Date: August 5, 2003

Per our conversation on July 18, please provide a quotation for modifying the Emission Designator on the FCC grant for the COM400 Beltpac (FCC ID: BYMC420).

Figure 1 COM400 Modulated with 2500Hz + 16 dB

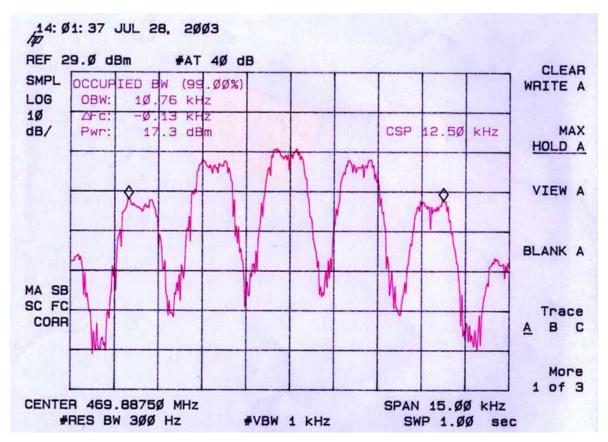
In addition, the occupied bandwidth measurement was in error for the Canadian submission. As can be seen on the attached graph, when using the spectrum analyzer's occupied bandwidth measurement function, the occupied bandwidth does not exceed 10.76 kHz. So, also please quote modifying the Canada certification (1860195400) to reflect a bandwidth of 12.5 kHz.
